STAFF RECOMMENDATION

NCPC File No. 7009

**DEPARTMENT OF COMMERCE HEADQUARTERS
(HERBERT HOOVER BUILDING)
NATIONAL AQUARIUM ENTRANCE**

June 24, 2010

Rendering of wall alternatives (also showing proposed signage)

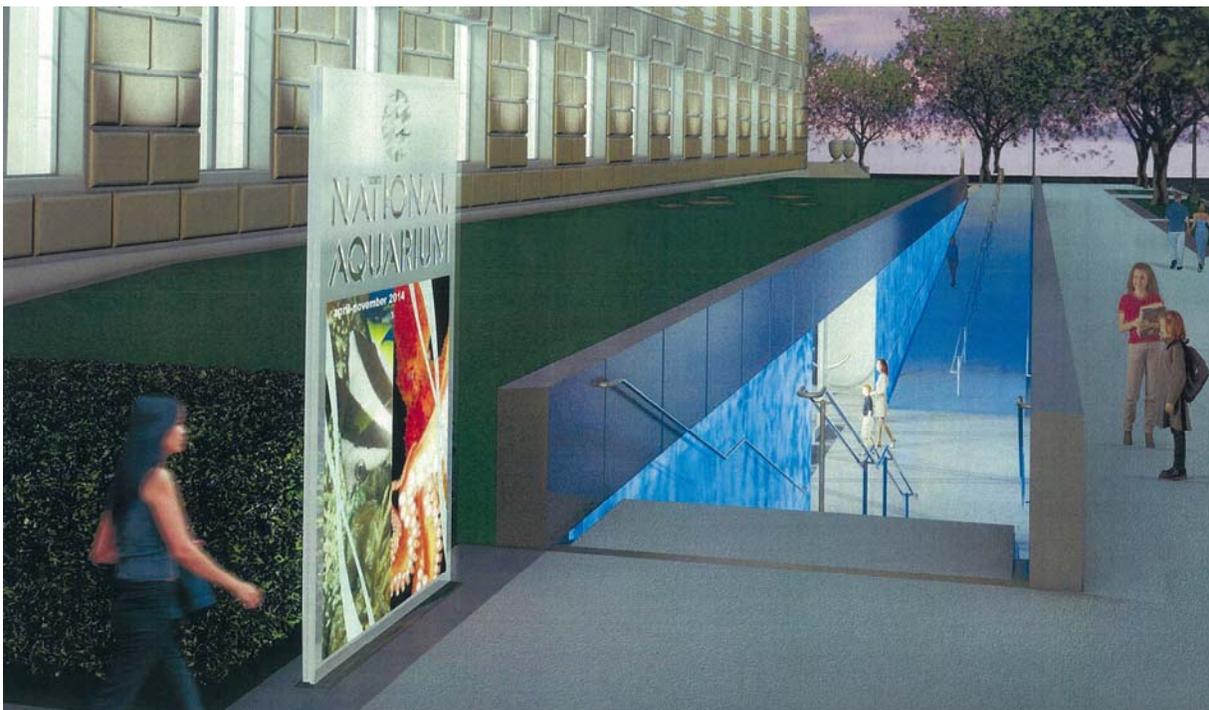
GSA is continuing to refine the design of the outer pavilion wall in close consultation with NCPC and all other interested stakeholders. Staff has reviewed the two submitted wall alternatives and is satisfied with the direction the design is going in. Both alternatives are relatively simplistic and maintain a clean visual line that does not compete with the south elevation of the HCHB. Staff will continue to work with GSA and the other stakeholders to identify and finalize one wall design prior to the project being submitted for preliminary and final approval.
